Town Hall

Town of Belmont ADA Transition Plan

March 2021

Institute for Human Centered Design

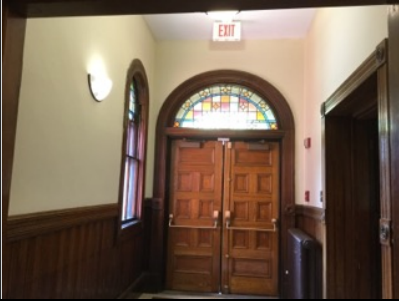
- Recommend providing contrasting strips on stair treads.
- Recommend providing a sign with raised characters and braille at permanent rooms where no sign is provided.
- Recommend providing handrail extensions that extend 12" past the bottom stair at exterior stairs at the northwest exits.
- Recommend providing a second handrail at the stair to the stage.
- Recommend providing handrails at exterior stair from the dressing room level.
- Recommend providing a 48" wide stable, firm and slip resistant walking surface around accessible picnic tables. See the following image:

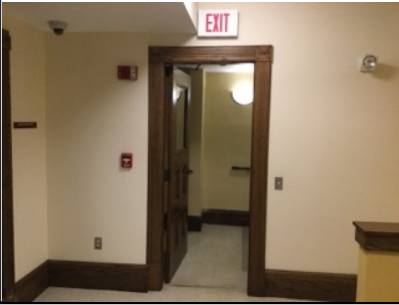
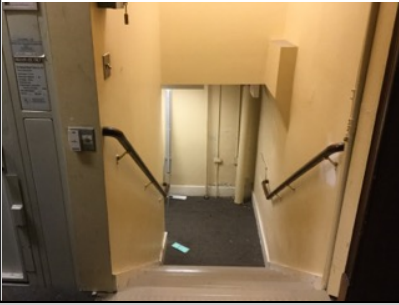
Emergency Exit												
5	Southwest Exit	1		Emergency Exit	N/A		Tactile sign not provided at exit	-	Provide tactile exit signs with raised characters and braille at exit doors. Mount signs between 48"- 60" above the finished floor located on the latch side of the door.	1	232	\$232

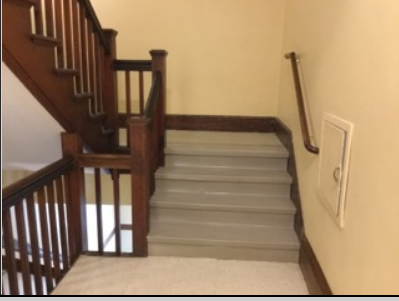
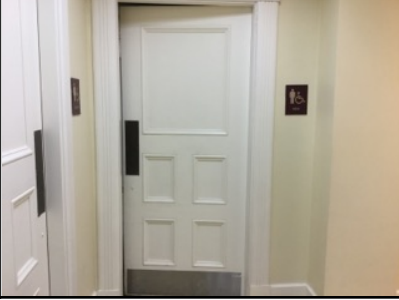
Doors, Doorways, & Gates												
20	Women's Toilet Room on Southwest	1		Doors, Doorways, & Gates	Toilet Room		Maneuvering clearance(s) not provided	-	Relocate trash bin.	1	Labor	\$0

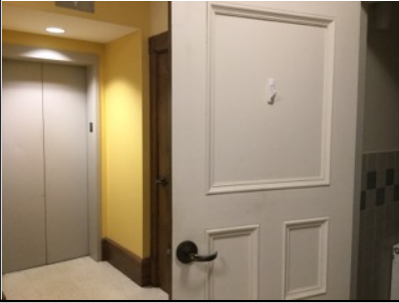
ID	Location	Floor	Room	Element	Type	Photo	Issues	Current Measure	Recommendations	Quantity	Price	Cost Estimation
Stairways												
31	Stair to Floor 2R	2R		Stairways	Egress		Handrail not provided on both sides	-	Provide a handrail on each side.	1	1320	\$1320
32	Staircase From Ground Floor to First Floor	G		Stairways	Egress		Handrails do not extend 12" from stairs	1	Bottom: Ensure handrails extend to one tread depth beyond the last riser (on the left handrail).	1	332	\$332
33	Stair 1	1		Stairways	Egress		Handrails not continuous where required	-	Provide a continuous handrail on the interior side of stair.	1	1320	\$1320
Signage												
34	Credit Union Office	2R		Signage	Designation		Sign not located on the latch side of the door	-	Locate sign at permanent rooms alongside the door on the latch side.	1	Labor	\$0
35	Men's Toilet Room	G		Signage	Designation		Sign not located on the latch side of the door	-	Locate sign at permanent rooms alongside the door on the latch side.	1	Labor	\$0

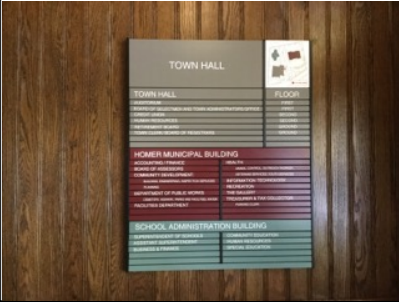
49	Women's Toilet Room on Southwest	1		Dispensers	Paper Towel Dispenser		Dispenser acts as a protruding object	-	Relocate paper towel dispenser out of the circulation path.	1	256	\$256
